**COUNTY OF YOLO**  
**DIVISION OF INTEGRATED WASTE MANAGEMENT**  
**CALIFORNIA UNIFORM PUBLIC CONSTRUCTION COST ACCOUNTING ACT**  
**CONTRACT CHANGE ORDER NO. #1**

**Project:** Waste Management Unit 2 Drainage System Modifications

**Location:** Yolo County Central Landfill

**Date:** 9/26/25

Change Order No 1. Detail

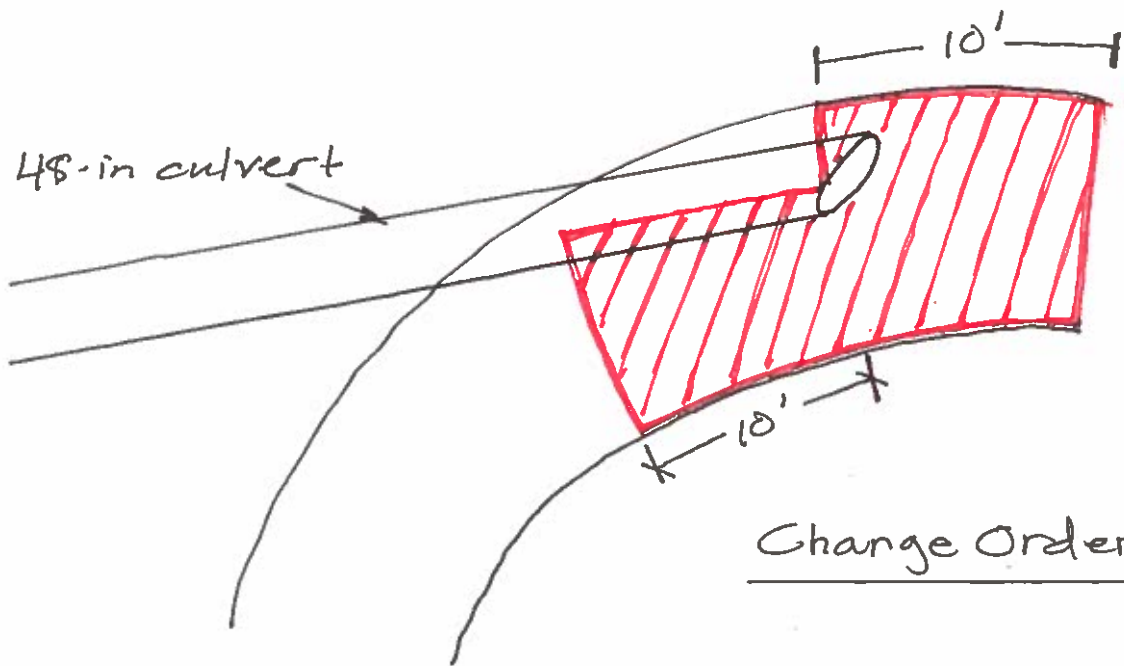
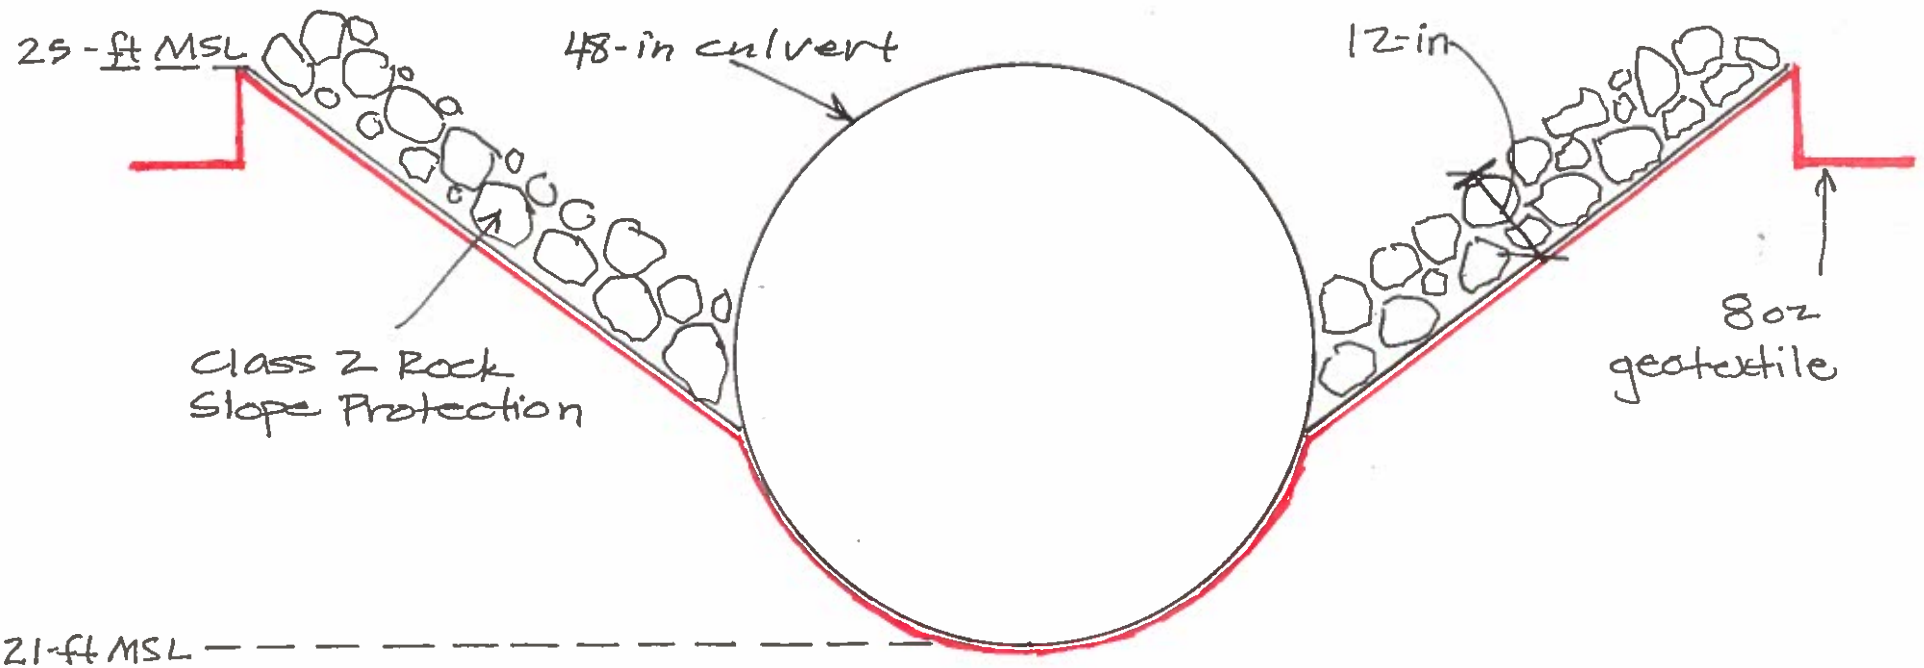
1. 26 linear feet of 48-inch diameter storm drain.
2. 60 square feet of asphalt concrete paving, thickness to match existing
3. Install CLSM backfill within road section
4. Install aggregate base backfill in road section
5. Utilize shoring and traffic control as necessary
6. Install rock slope protection including geotextile
7. Modify grades as necessary to accommodate new features
8. Omit relocation of one condensate sump

DESCRIPTION	QTY	UNIT PRICE	AMOUNT
48 Inch Storm-Drain pipe alignment modification and inlet protection	1.00	20,100.00	20,100.00
<b>Change alignment of 48" SD road crossing:</b>			
Includes F&I additional approx. 26LF of 48" Storm drain pipe			
Additional approximately 60SF of AC paving			
CLSM backfill within road section			
AB backfill as required			
Shoring as necessary			
Traffic control as necessary			
Fit/Modify inlet to grades			
<b>SD Inlet Protection:</b>			
Confirm grades to new inlet alignment			
Excavate subgrade for RSP			
Excavate and backfill geotextile anchor trench			
F&I Geotextile			
F&I RSP			
Traffic control as necessary			
<b>Credit</b>			
Relocation of one leachate sump	-1.00	(2,100.00)	(2,100.00)
